**License Application, Attachment A, “Proposed License Conditions”**

**License Application, Appendix A, "Proposed Technical Specifications"****RAI TS-1:**

**Figure K.3.1-1**  
**61BT-DSC Confinement Boundary**

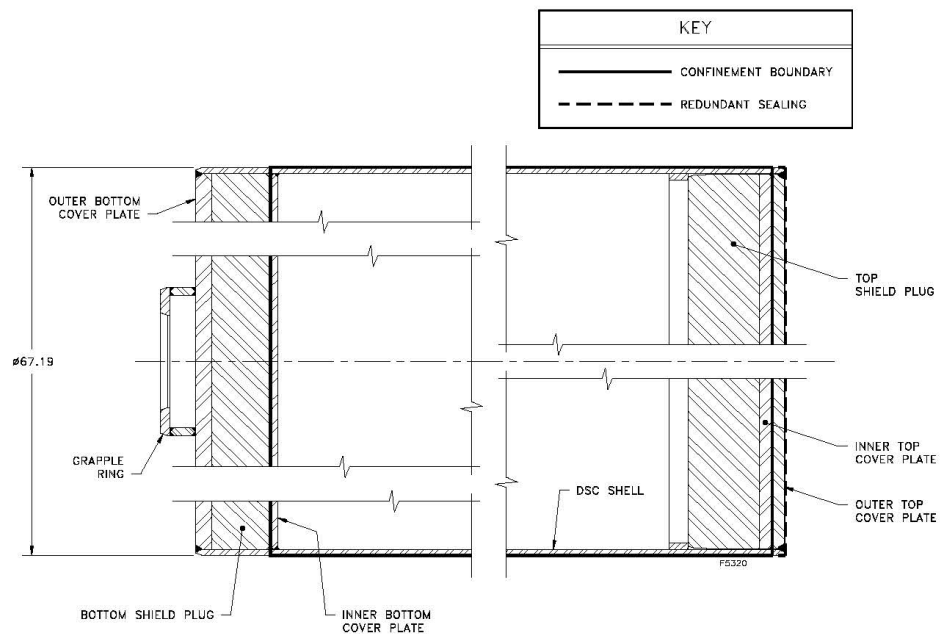
Clarify the terms, “to the extent practicable,” and, “by this test,” contained in Proposed License Condition 22 which states, “Prior to removing the shipping cask closure lid, the gas inside the shipping cask shall be sampled to verify that the canister confinement boundary is intact *to the extent reasonably practicable by this test.*”

As written, the license condition is vague and does not identify a specific procedure, test, or acceptance criteria.

This information is needed to determine compliance with 10 CFR 72.24(b), (c), (d), (e) and (l) and 72.120(a).

ISP has revised the License condition to clarify that the test to be performed is that referenced in Sections 5.1.3.1, 7.2, 8.2 and the operating procedures in the appendices in accordance with QP-10.02. License Condition 22 is revised to read, “A Post-Transportation Verification shall include an evacuated volume helium leak test on 100% of the canisters that are received at the WCS CISF to ensure that the accessible portions of the confinement boundary are leak tight as defined in ANSI N 14-5 following transport to the site.” The language in Section 4.5.5 of the SAR is also updated consistent with this change.

The confinement boundary of each canister is leak tested in accordance with ANSI-N 14.5 during fabrication and during closure of the canister. The reference “to the extent practicable” is meant to acknowledge the fact that due to the geometry of the canisters it is impossible to leak test the entire confinement boundary once fabrication and closure of the canister is complete. Incorporation by reference is employed in Sections A.11.1, B.11.1, C.11.1, D.11.1, E.11.1.1, E.11.2.1, F.11.1.1 and G.11.1.1 to define the confinement boundary for each canister. By way of example, SAR Section C.11.1 incorporates Figure K.3.1-1 by reference from TN Document NUH-003, Revision 14, “Updated Final Safety Analysis Report for the Standardized NUHOMS® Horizontal Modular Storage System for Irradiated Nuclear Fuel.” (Basis for NRC CoC 72-1004). Figure K.3.1-1 from the NUHOMS® SAR provides the figure that shows the components and welds that make up the confinement boundary for the 61BT DSC. Figure K.3.1-1, reproduced below, shows that portions of the confinement boundary are enclosed by other welded components (bottom cover plate, top cover plate etc.). Since all of the other canisters have similar designs, Figure K.3.1-1 is representative for all.
